Project	<b>IEEE 802.16 Broadband Wireless Access Working Group</b> < <a href="http://ieee802.org/16">http://ieee802.org/16</a> >
Title	<b>Proposed text and ASN.1 code for service flow Management</b>
Date Submitted	<b>2007-05-08</b>
Source(s)	Joey Chou Intel Corporation <a href="mailto:joey.chou@intel.com">[mailto:joey.chou@intel.com]</a>
Re:	
Abstract	This contribution proposes the text and ASN.1 code in wmanIf2mMib to support service flow management.
Purpose	Adoption
Notice	This document has been prepared to assist IEEE 802.16. It is offered as a basis for discussion and is not binding on the contributing individual(s) or organization(s). The material in this document is subject to change in form and content after further study. The contributor(s) reserve(s) the right to add, amend or withdraw material contained herein.
Release	The contributor grants a free, irrevocable license to the IEEE to incorporate material contained in this contribution, and any modifications thereof, in the creation of an IEEE Standards publication; to copyright in the IEEE's name any IEEE Standards publication even though it may include portions of this contribution; and at the IEEE's sole discretion to p

Figure 16— wmanIf2mBsCm structure

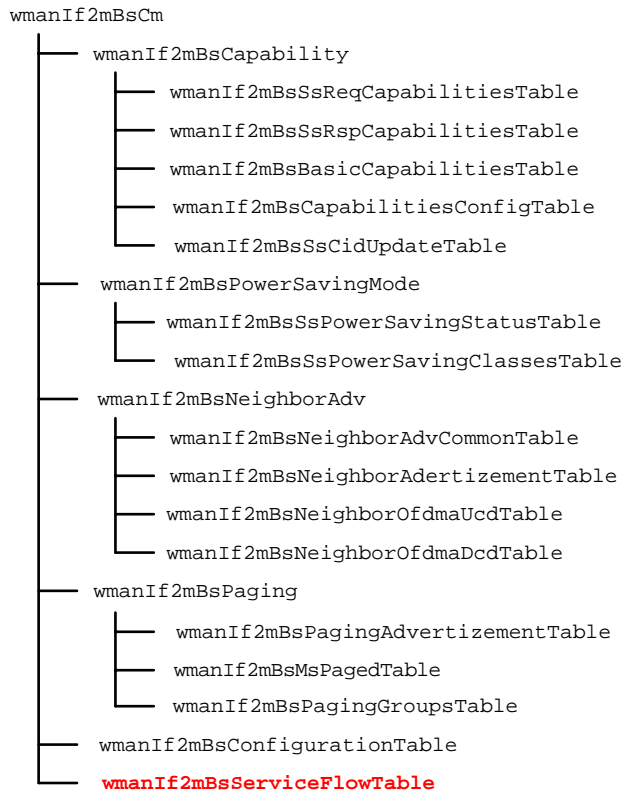
[Change Figure 16 as the following:]
